## **DETAILED ACTION**

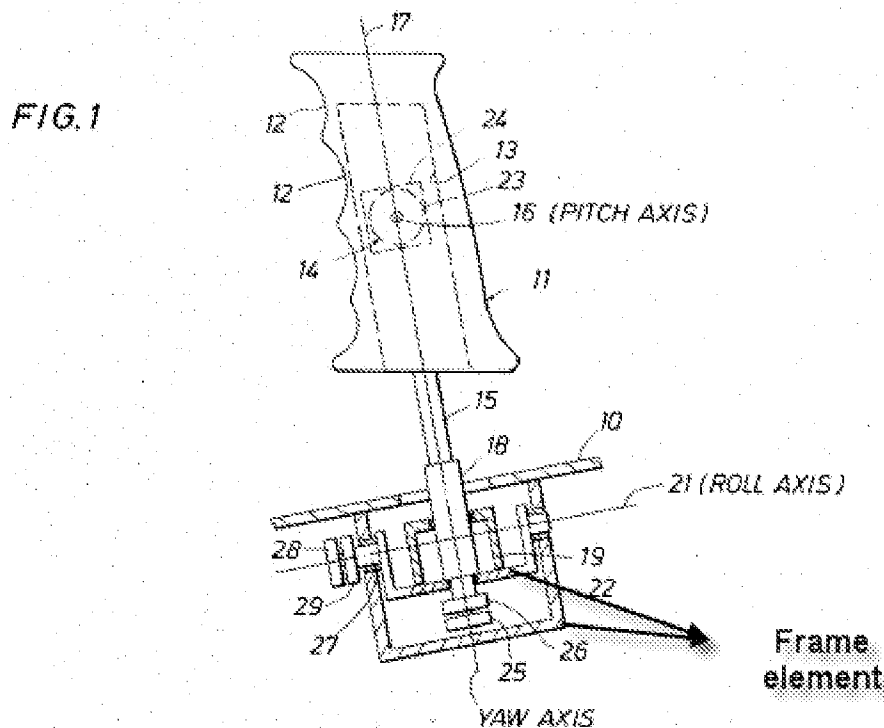
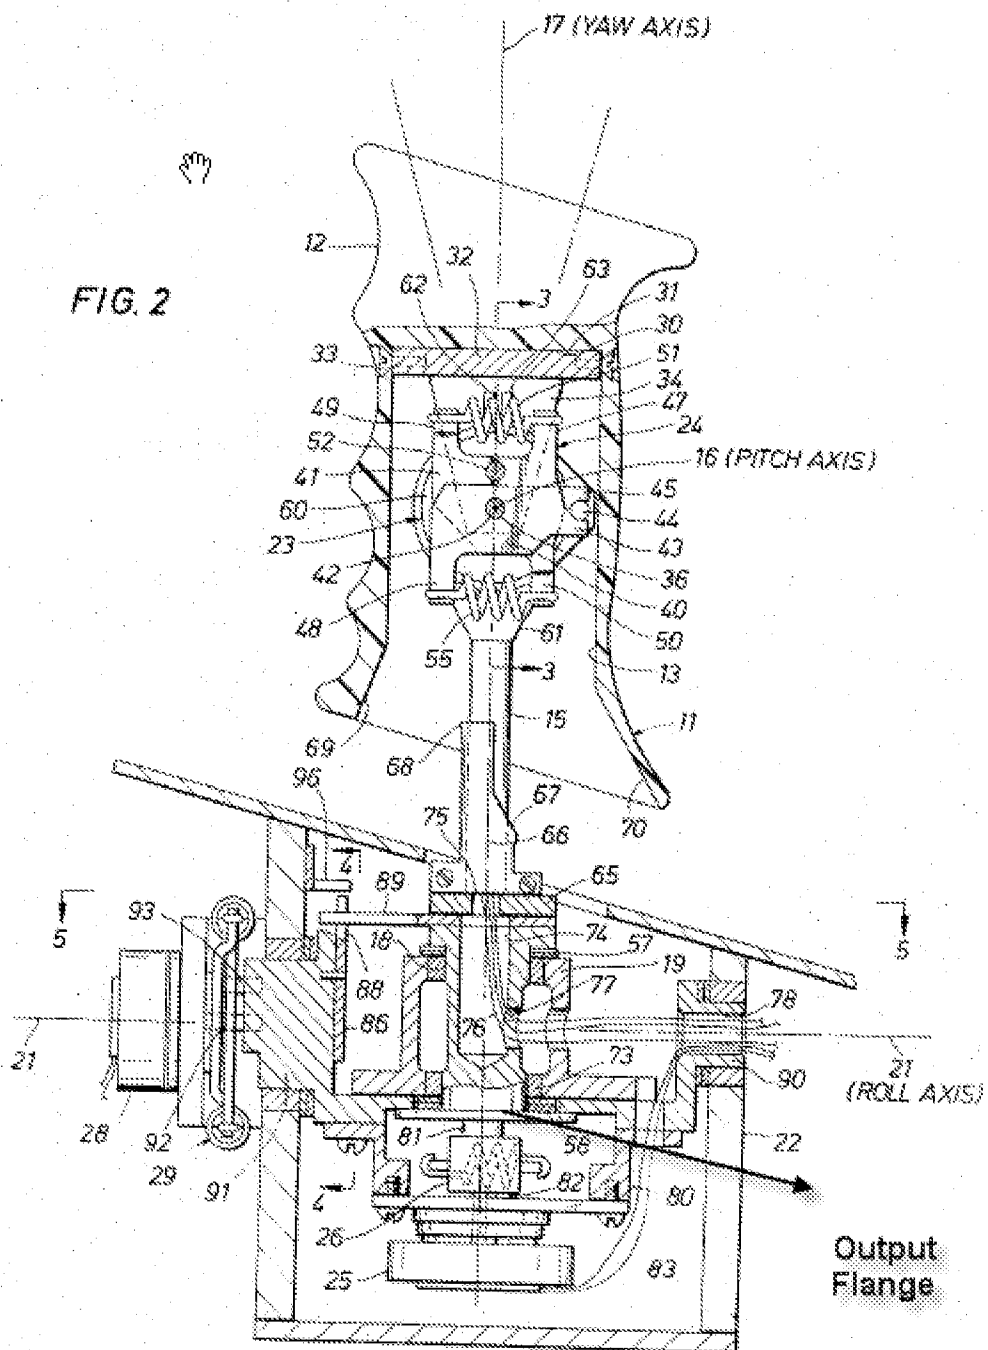
6. Claims 19- are rejected under 35 U.S.C. 102(b) as being anticipated by Bailey, Jr.. Bailey, Jr. discloses a similar device (see figure below).

**Regarding claim 29,**

- Bailey, Jr. discloses a holding means being a plate as labeled in figure 2, which is pivotable about the axis A discussed above and is fitted with the force sensor.

FIG. 6

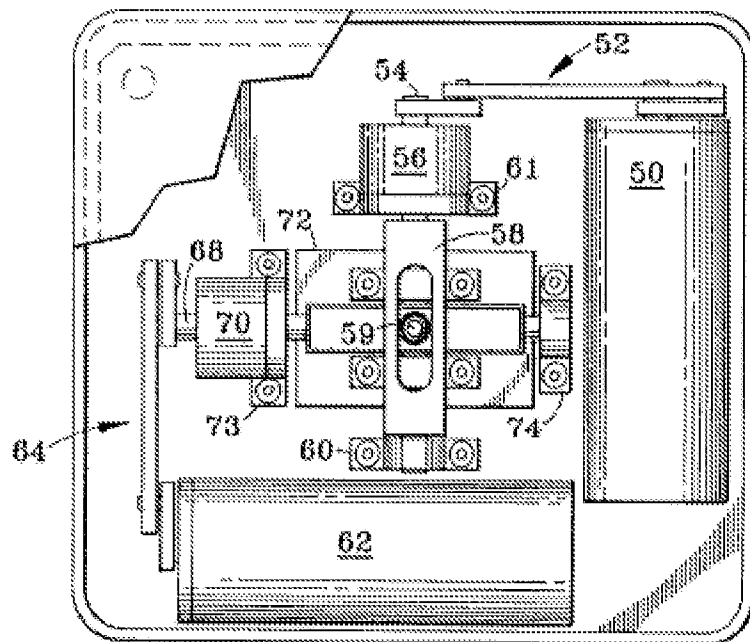
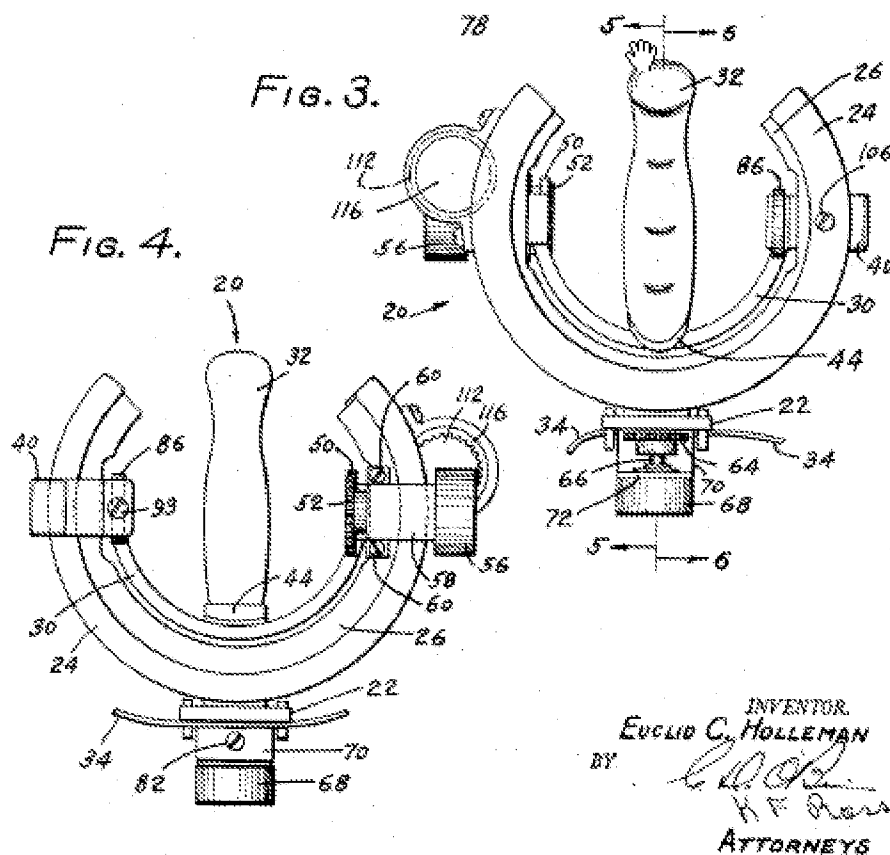
Marcus et al. teach a joystick device with an electronic control device (seen in the figure below and described in col. 1, lines 36+) comprising integrated force control and motor control via the electric motor (fig.6, Items# 50, 62) and a downstream

transmission(fig. 6, Items# 52). This electronic control device is used for the purpose of providing force feedback to the user. (col.2, lines 1-3)
